SUBJECT: NOVEMBER 2004 MONTHLY OPEN ITEM STATUS REPORT

The purpose of this letter is to update Duke Cogema Stone & Webster (DCS) on the status of the U.S. Nuclear Regulatory Commission's (NRC's) review of the Mixed Oxide Fuel Fabrication Facility (MFFF) Construction Authorization Request (CAR). The report covers the status through November 30, 2004.

## NRC Monthly Open Item Status Report: Mixed Oxide Fuel Fabrication Facility Construction Authorization Request

Status of Open Items since the NRC's Draft Safety Evaluation Report was  
issued on April 30, 2002.

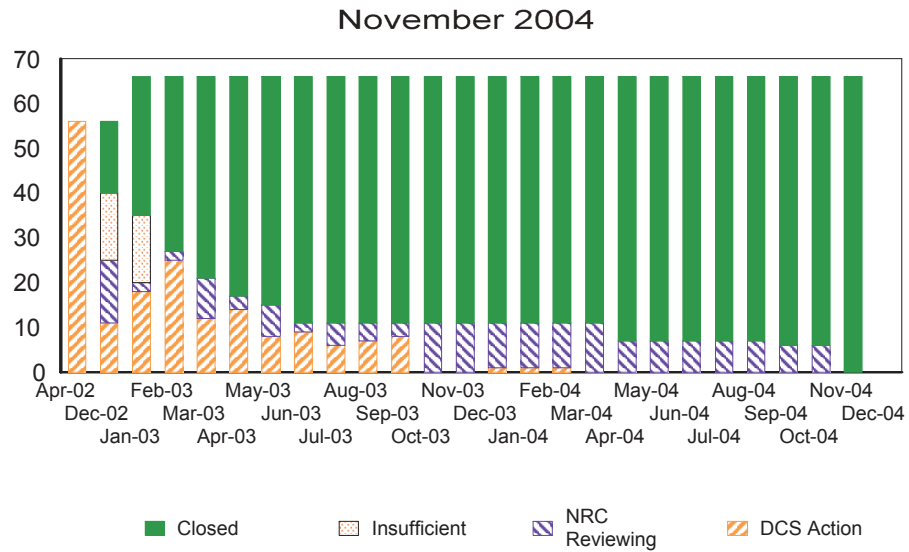
The attached table provides the status of the staff's review of open items. The table contains the 19 open items identified in Appendix A, of the April 30, 2003, Draft Safety Evaluation Report (DSER). The figure showing the closure of open items since April 2002, has been retained and shows the disposition of the original 66 open items.
